**ADDENDUM No. 1**

**Lincoln and Adams Elementary Schools 2024 Kitchen Upgrades**

Arch. Project #220117

## ADDENDUM NO. 1

#### **1. M2.02 ADAMS MECHANICAL PLANS**

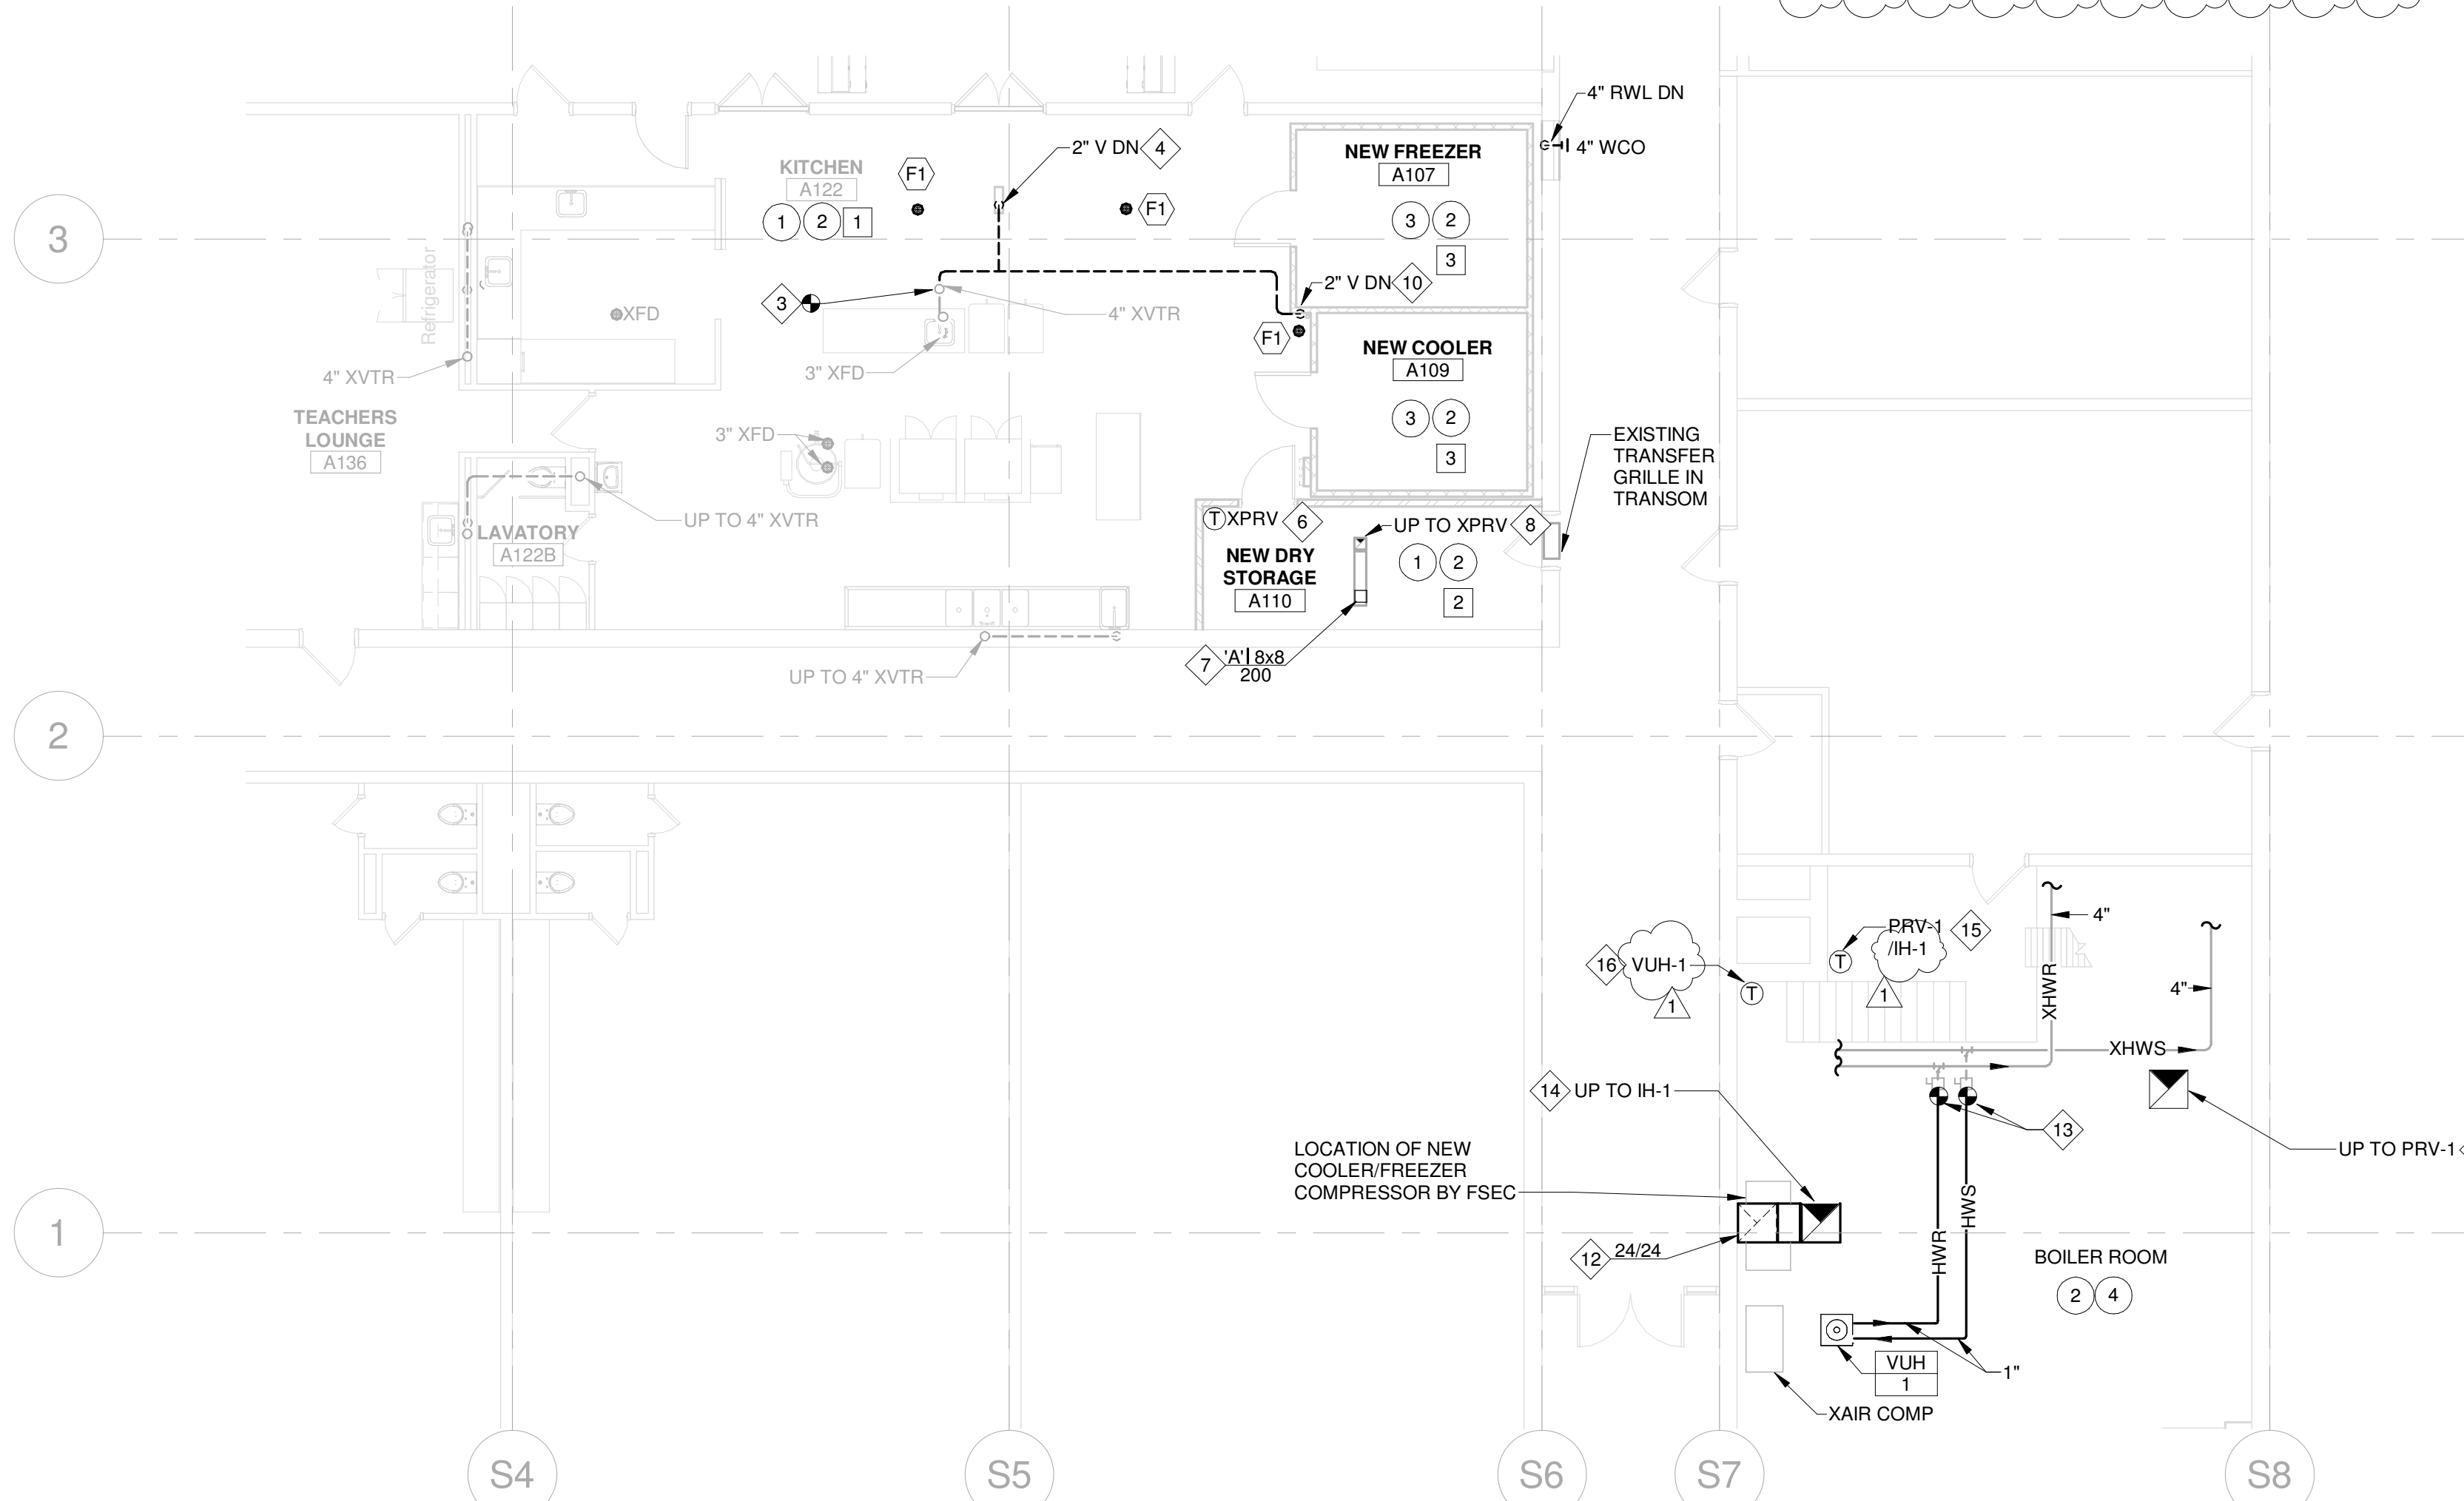
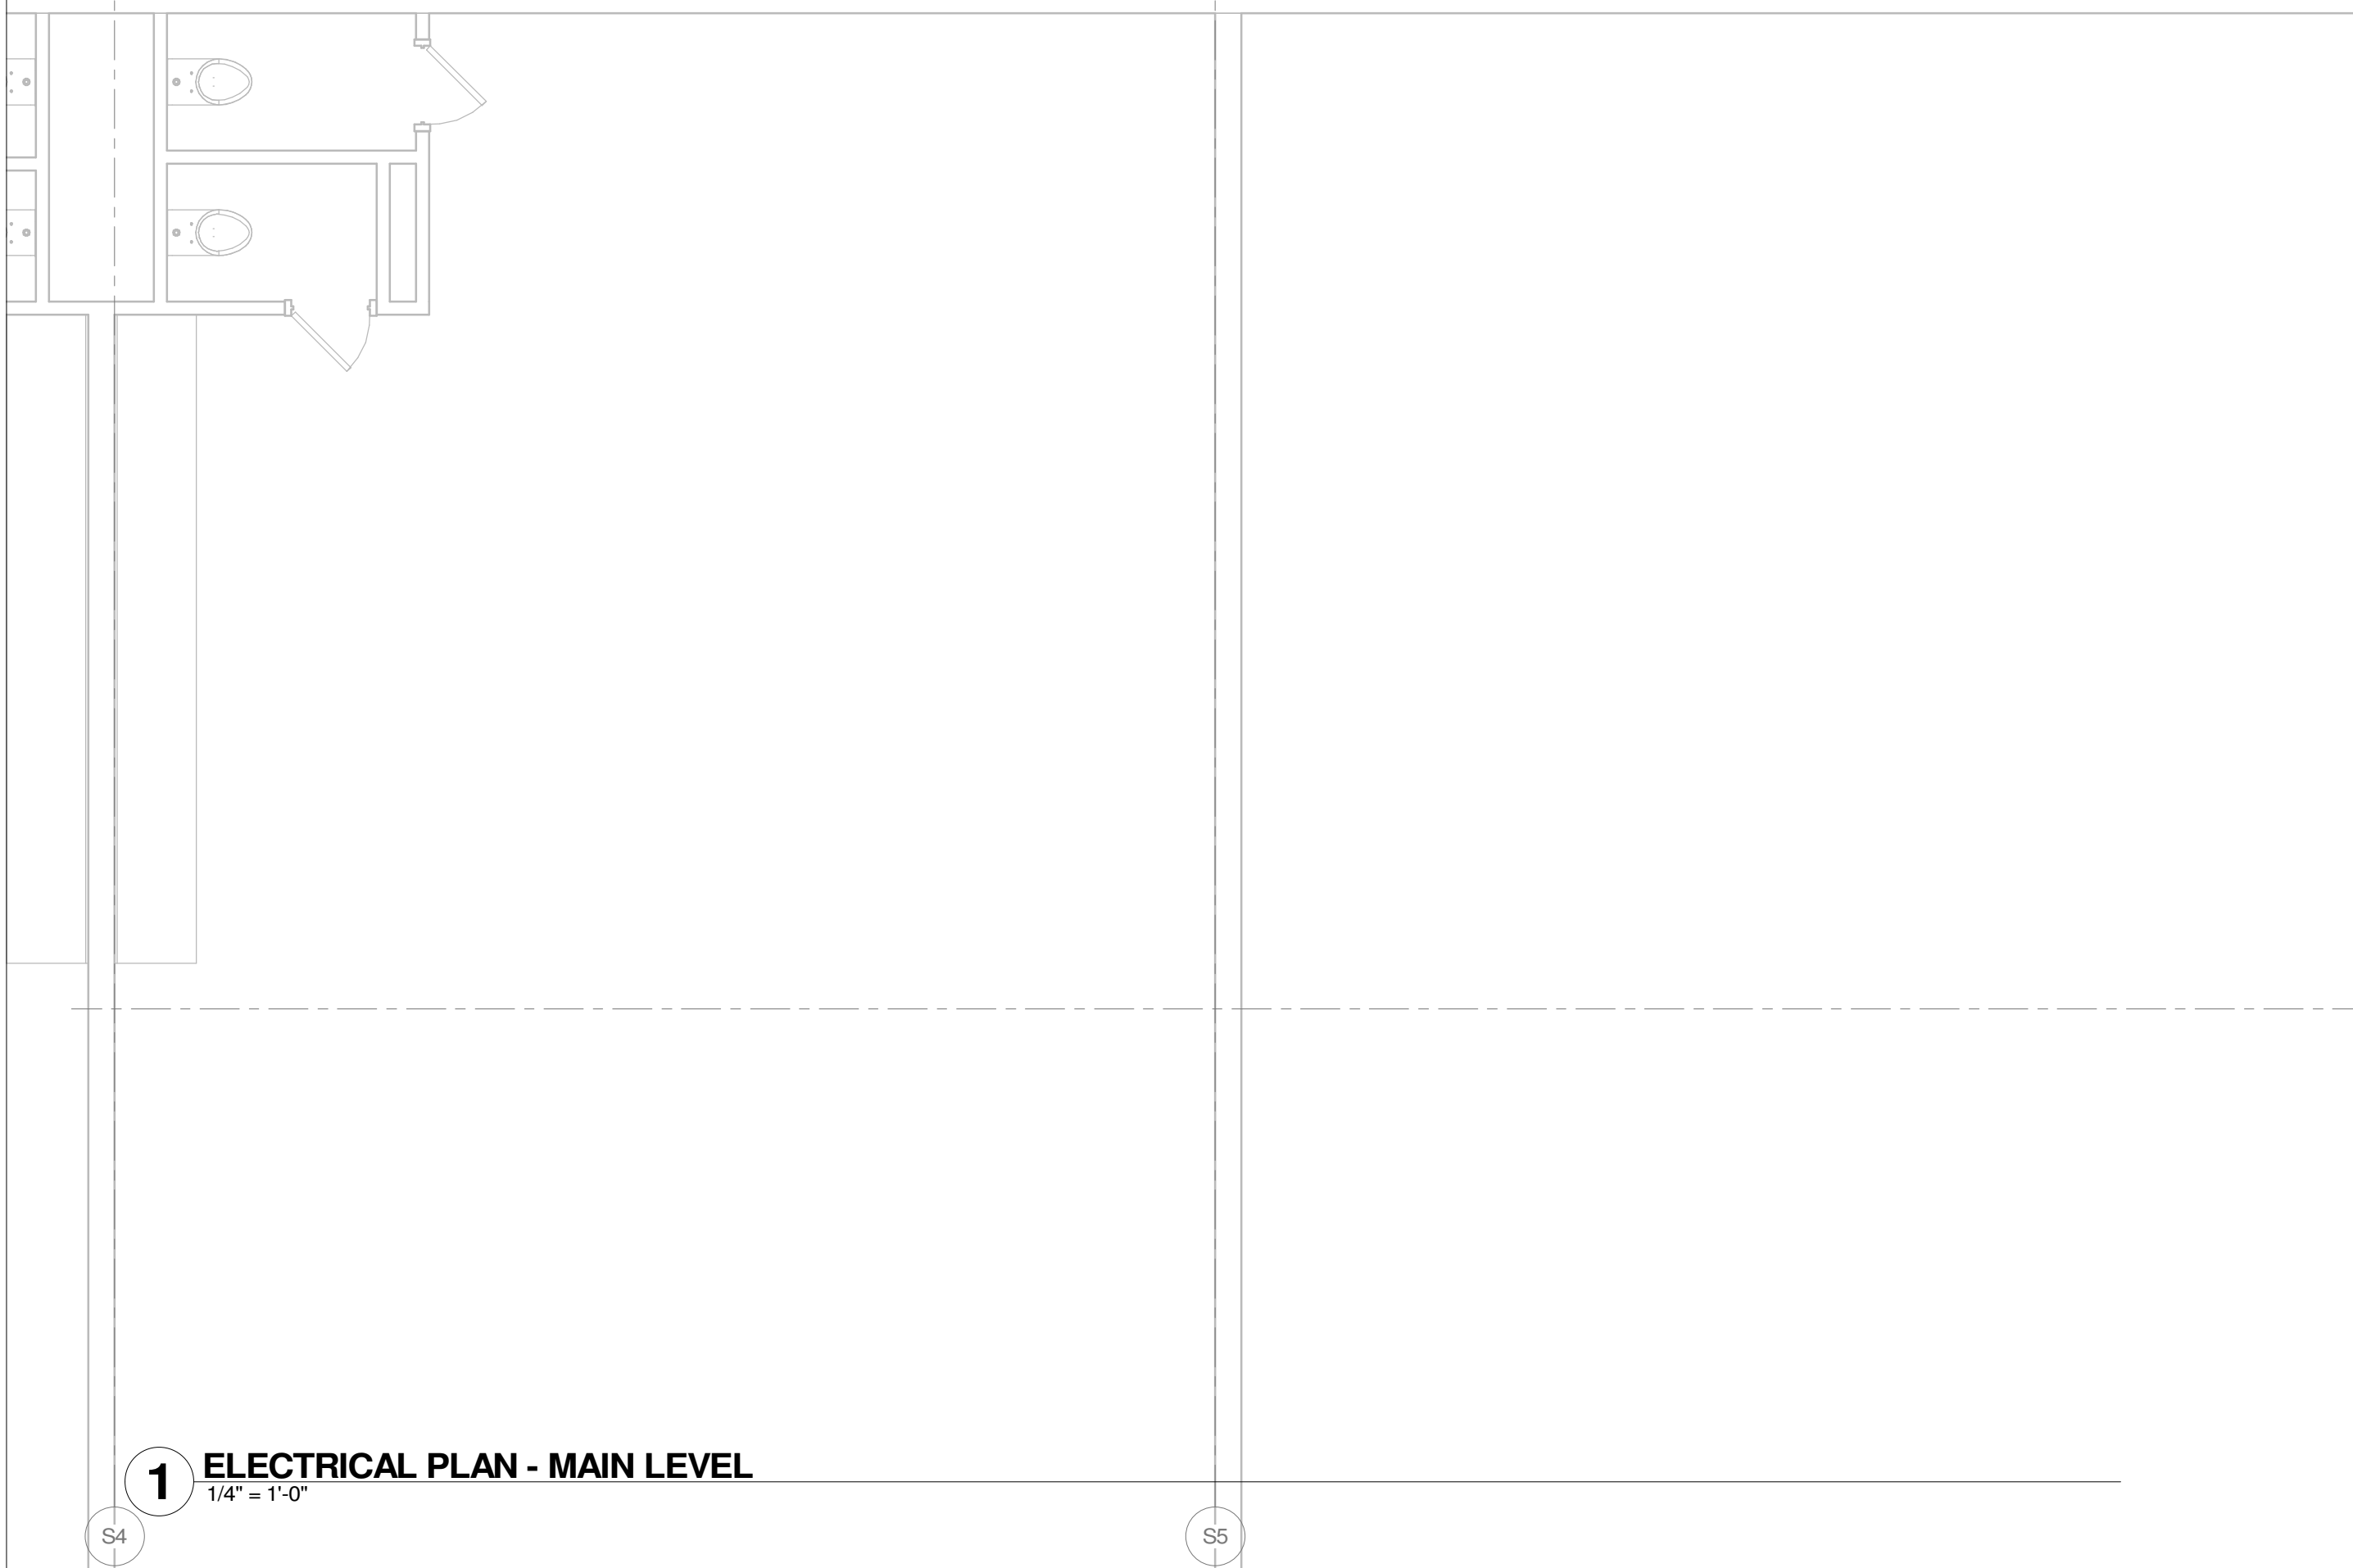
A. Refer to attached plan for revisions.
